Class II Permissive Change Request Letter

FCC ID: QZE280
Grant Date: 01/09/2009

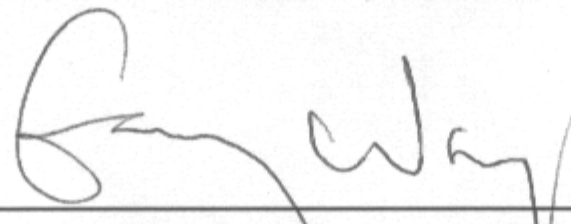
Pursuant to CFR 2.1043, Trapeze Networks, Inc. hereby requests a Class II Permissive Change. The model name shall be same as before. Modification: Add 802.11a Band 2 and Band 3 (5250~5350 MHz, 5470~5725 MHz) for this device. There is no change in hardware or in existing RF relevant portion. In addition, this device will disable channel as below for DFS application:

1. Indoor: HT20/legacy 11a ch.52 to 64 (open), ch.100 to 116 (open), ch.120 to ch.128 (disabled), ch.132 to 140 (open).
2. Indoor: HT40 ch.52 to 112 (open), ch.116 and 128 (disabled), ch.136 (open).
3. Outdoor: HT20/legacy 11a/HT40 ch.52 to 64 (open), ch.100 to 140 (disabled).
